Objection to reliance on the submitted drawing package

I object to the Council relying on the submitted drawing titled 2026-91657_+Grouped+Plans+and+Elevations_1144974.PDF as a reliable basis for assessing Plot 23.

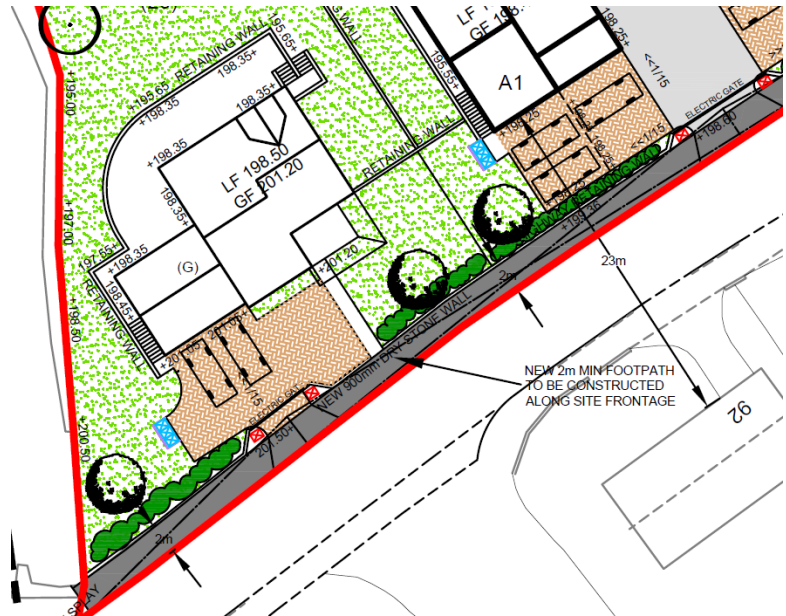
There is a further and separate problem with the submitted drawings. Since August 2025, plans relating to Plot 23 have continued to fail to depict the lawful side extension at No.92 Lingards Road.

That omission is material. No.92 is not simply the bungalow as originally built. It includes a lawful side extension, approved under planning permission **2018/92537**, and that extension forms part of the actual dwelling now affected by Plot 23. Any plan or assessment that omits the side extension presents an incomplete and inaccurate picture of the relationship between Plot 23 and No.92.

This is not a cosmetic omission. It affects the spatial relationship between the two properties, including the apparent angle, separation, outlook, dominance and relationship with habitable-room windows. If the lawful side extension is not shown, the Council cannot safely assess how Plot 23 relates to the dwelling that actually exists on site.

Before this application is determined, the applicant should be required to provide corrected plans which accurately show the lawful side extension at No.92 and its relationship with Plot 23. The Council should then reassess the impact of Plot 23 by reference to the actual existing dwelling at No.92, not an outdated or incomplete plan representation.

Figure 1 - Annotated extract identifying plan contradictions

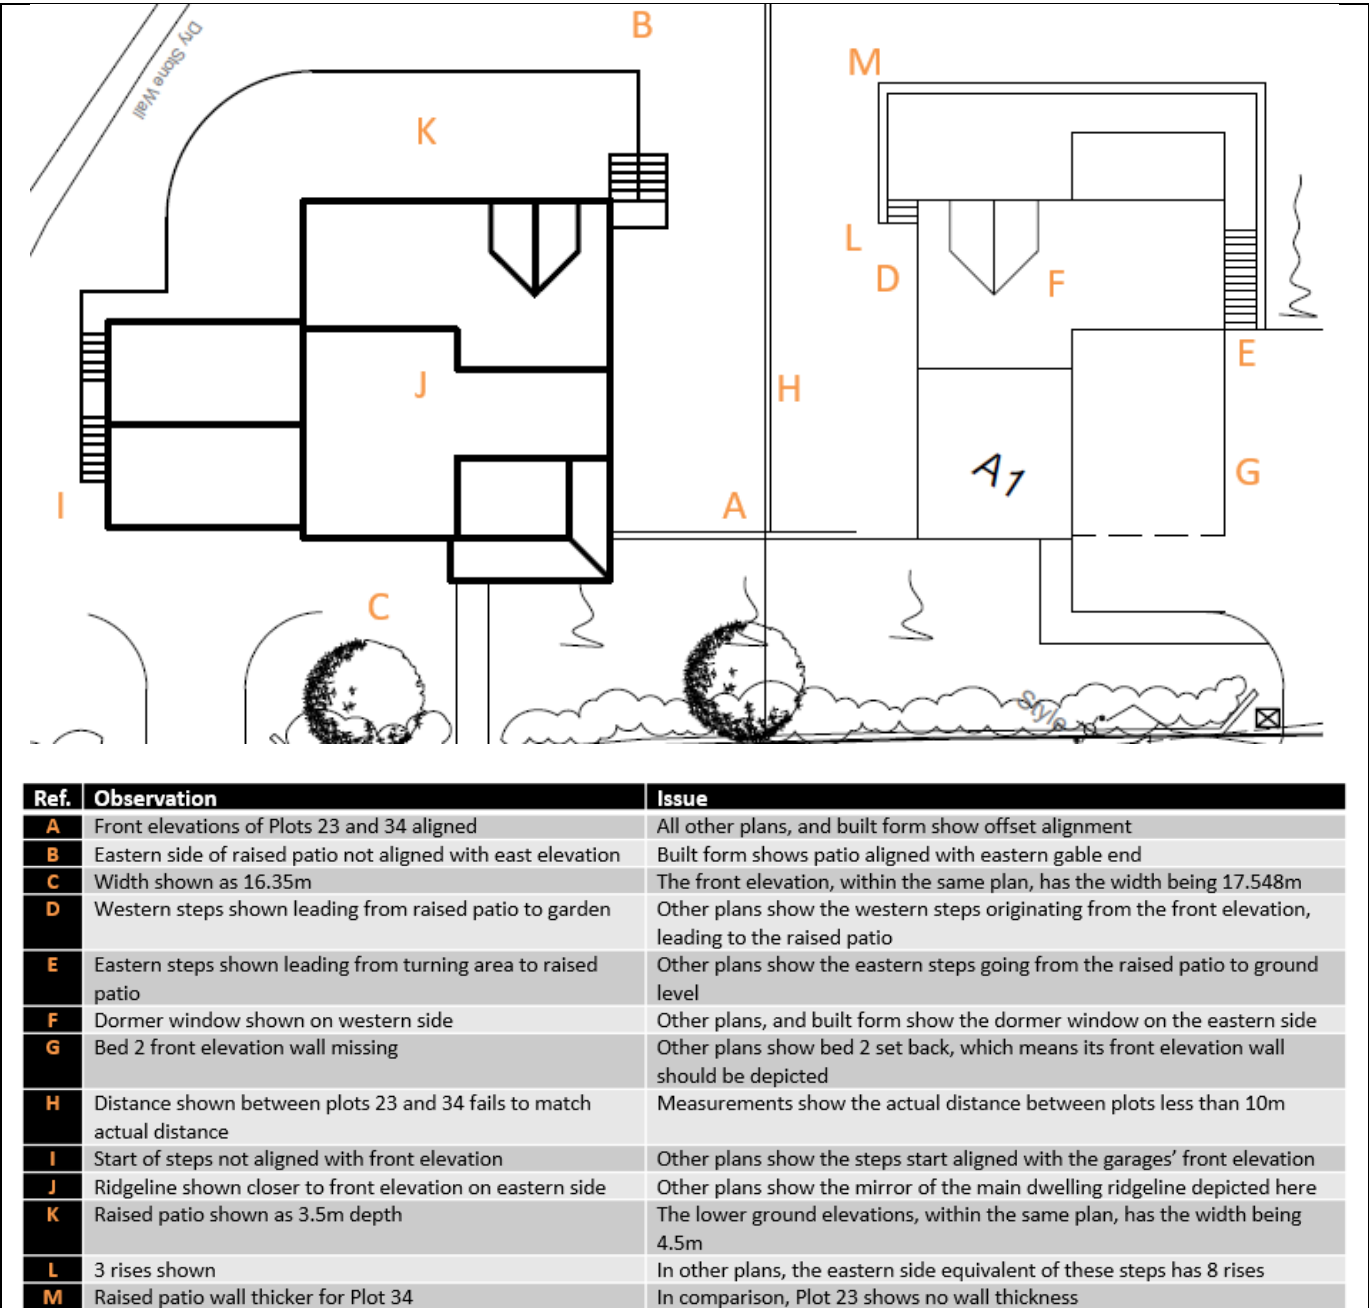
The marked extract from 2026-91657_+Grouped+Plans+and+Elevations_1144974.PDF identifies the following concerns. The contradictions identified below are not intended to be exhaustive. They are examples of the inconsistencies that are apparent from reviewing the submitted drawings and comparing them with the built form on site. Their purpose is to demonstrate that the plan set is not internally coherent and that the Council cannot safely rely upon it without requiring a corrected, consistent set of drawings.

Ref.	Observation	Issue
A	The front elevations of Plots 23 and 34 are shown aligned.	Other plans, and the built form, show offset alignment.
B	The eastern side of the raised patio is not aligned with the east elevation.	The built form appears to show the patio aligned with the eastern gable end.
C	The width is shown as 16.35m.	The front elevation within the same plan has the width as 17.548m.
D	The western steps are shown leading from the raised patio to the garden.	Other plans show the western steps originating from the front elevation and leading to the raised patio.
E	The eastern steps are shown leading from the turning area to the raised patio.	Other plans show the eastern steps going from the raised patio down to ground level.
F	The dormer window is shown on the western side.	Other plans and the built form show the dormer window on the eastern side.
G	The Bed 2 front elevation wall appears to be missing.	Other plans show Bed 2 set back, meaning its front elevation wall should be depicted.

H	The distance between Plots 23 and 34 does not appear to match the actual distance.	Site measurements indicate the actual gap is less than 10m, approximately 9.592m.
I	The start of the steps is not aligned with the front elevation.	Other plans show the steps starting aligned with the garage front elevation.
J	The ridgeline is shown closer to the front elevation on the eastern side.	Other plans show the mirror of the main dwelling ridgeline being depicted here.
K	The raised patio is shown as 3.5m deep.	The lower-ground elevations within the same plan show the comparable width as 4.5m.
L	Three rises are shown.	Other plans show the eastern equivalent of these steps with eight rises.
M	The raised patio wall is shown thicker for Plot 34.	By comparison, Plot 23 shows no equivalent wall thickness.

I therefore ask the Council to require the applicant to submit a corrected, internally consistent set of plans before this application is determined. Those corrected plans should clearly show:

- the true width of Plot 23;
- the true position of Plot 23 relative to Plot 34;
- the actual measured gap between Plot 23 and Plot 34;
- the correct raised patio depth and alignment;
- the correct location, direction and number of steps;
- the correct dormer position;
- the correct Bed 2 wall arrangement;
- the correct lower-ground / under-garage layout;
- the correct retaining wall and wall-thickness details;
- the lawful side extension at No.92 Lingards Road;
- the relationship between Plot 23 and the actual existing dwelling at No.92, including the side extension and affected habitable-room windows;
- which drawings supersede earlier or contradictory drawings.
